Re: **License SUA-1473 Docket 40-8905**
Response to October 31, 2005 Request for Additional Information

Response to Request for Additional Information

**Rio Algom Mining LLC
License Amendment For Alternate Concentration Limits
Non-hazardous Constituents**

Figure 1
Long Term Site
Maintenance
Boundary

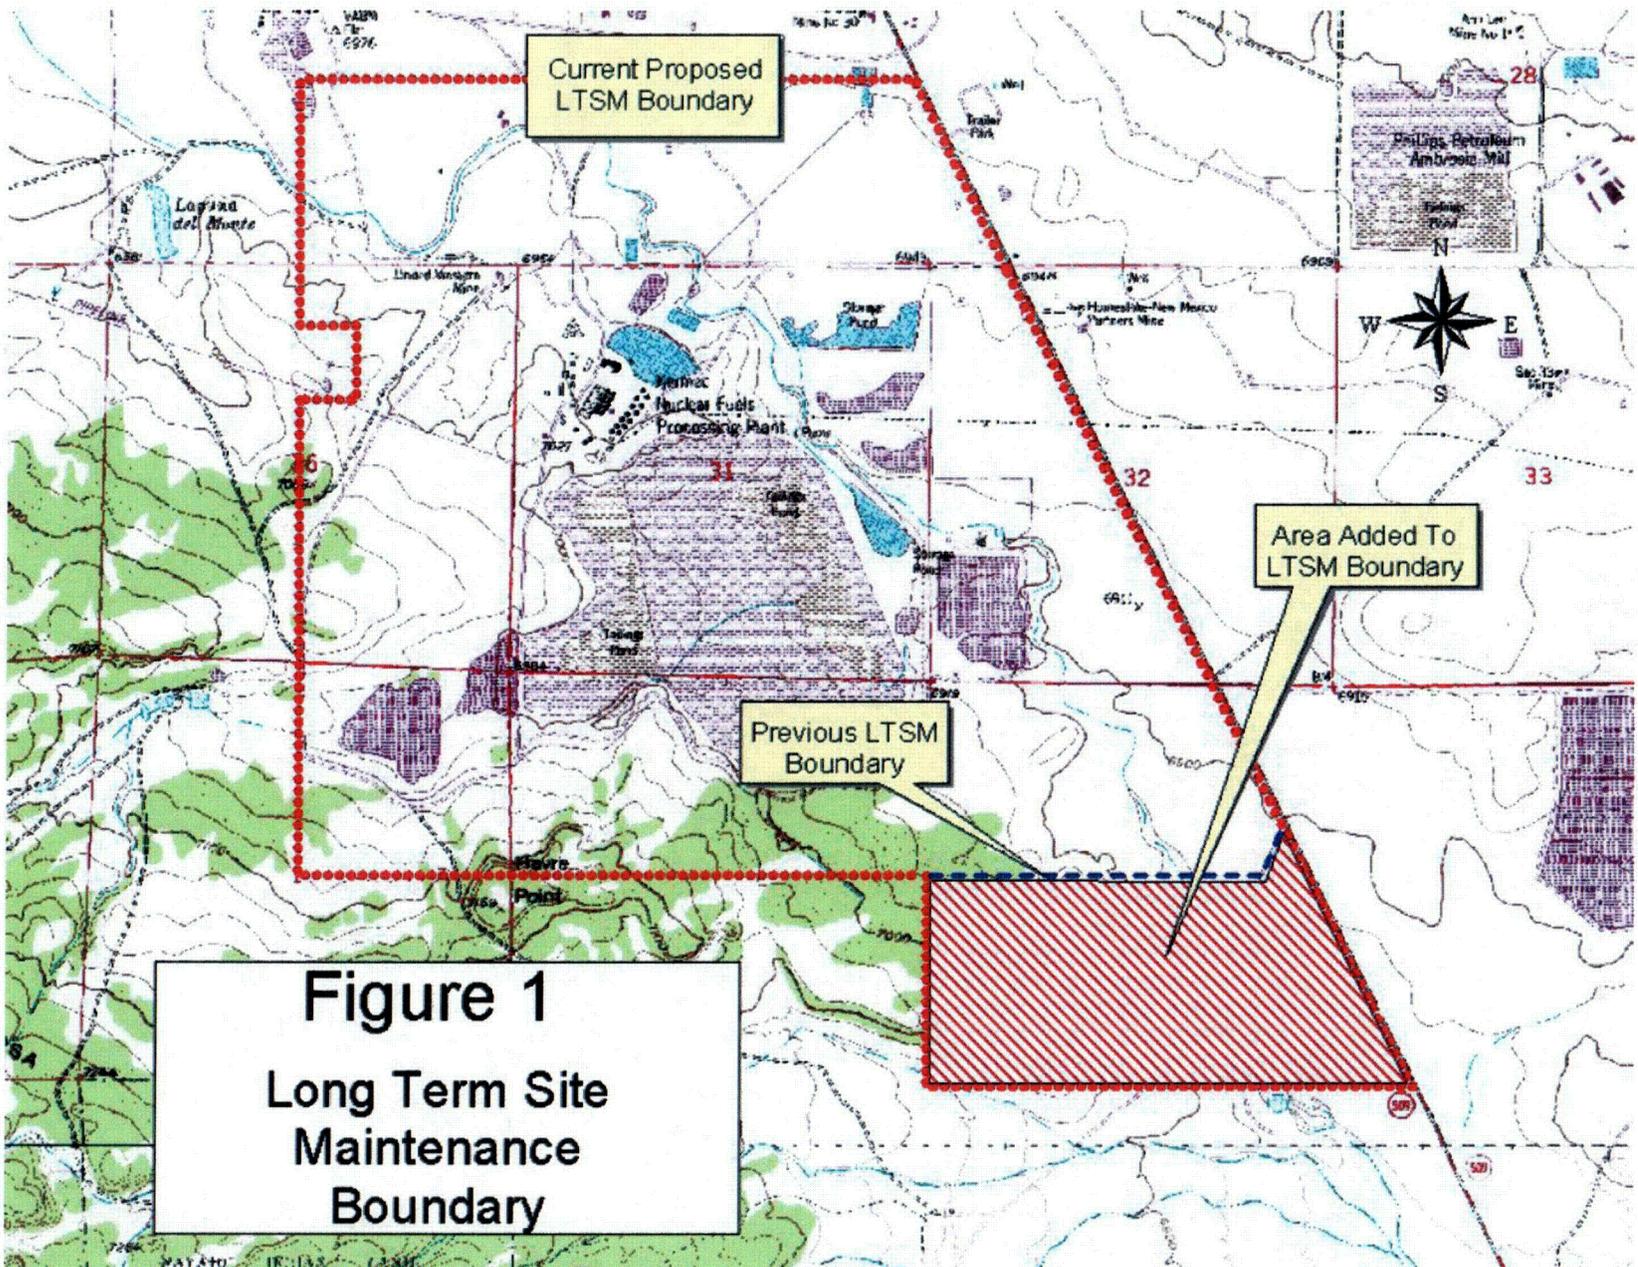
RAM should provide an assessment of the non-hazardous constituent concentrations in ground water at the point of exposure (POE) and the methods used in this assessment.

Rio Algom has requested that the DOE Office of Legacy Management establish the Long Term Surveillance and Maintenance (LTSM) boundary to include the southern part of Section 5 and that portion of Section 4 that is west of Highway 509 (Figure 1). This boundary is necessary in order to support the ACL application. Monitor well MW-24, which is located in the southwest corner of Section 4 approximately 2800 feet southeast of well 5-08, will constitute the POE for the alluvium. However, in order to maintain consistency with past model work, the following analysis was performed by maintaining the POE at well 5-08.

Figure 7. Chloride in the Dakota Solute Model

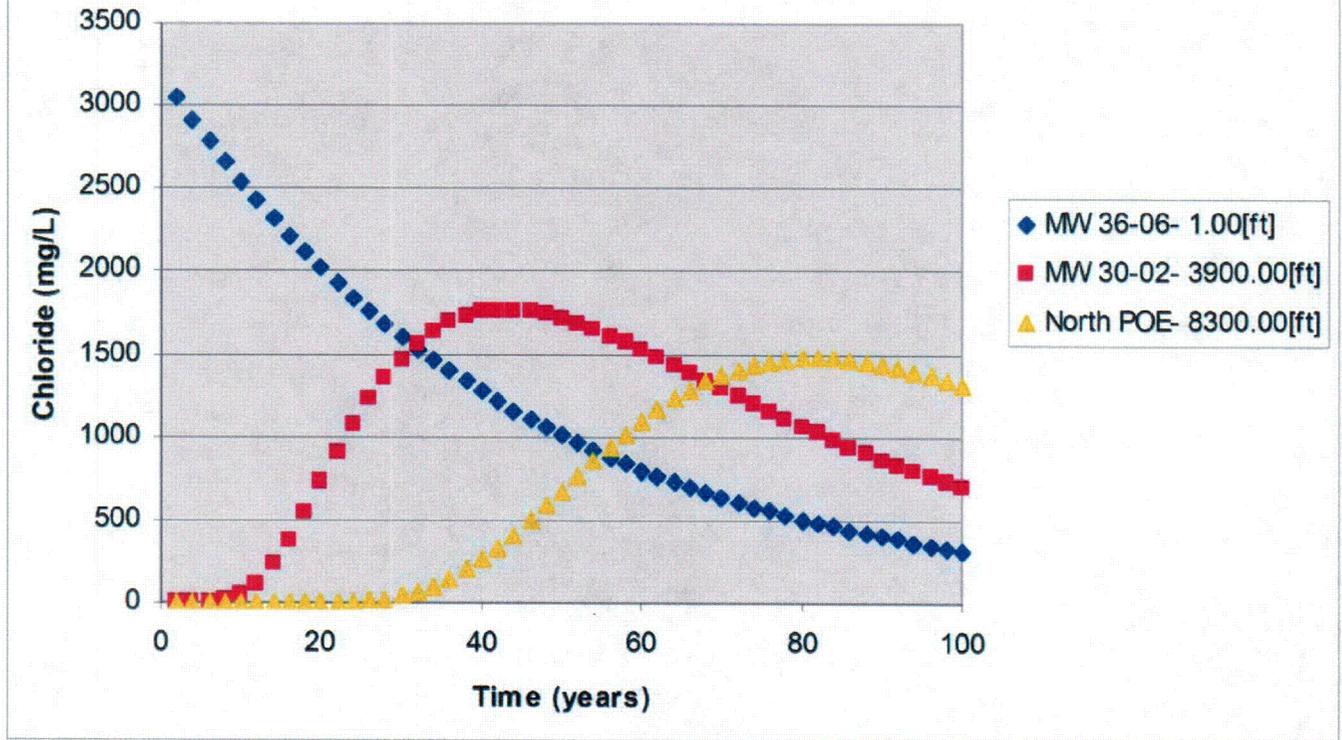
RAM states that the non-hazardous ACLs will be the same for both the alluvial and bedrock aquifers. This does not appear to be technically defensible. Although ground water would migrate from the alluvial to the bedrock aquifers, attenuation to some degree would likely occur. This is evident by the proposed ACLs for the hazardous constituents, which are lower for the bedrock aquifers than for the alluvial aquifer. RAM should present its rationale for proposing similar bedrock and alluvial ACLs.

Rio Algom used modeling procedures identical to those described above (Comment 2) to assess concentrations of non-hazardous constituents at the POE over time. Results are presented in Figure 7 (chloride), Figure 8 (nitrate), Figure 9 (sulfate), and Figure 10 (TDS). Modeling was only completed for the Dakota because the transport distance is the same as that for the other units and initial concentrations of all constituents were highest in the Dakota.
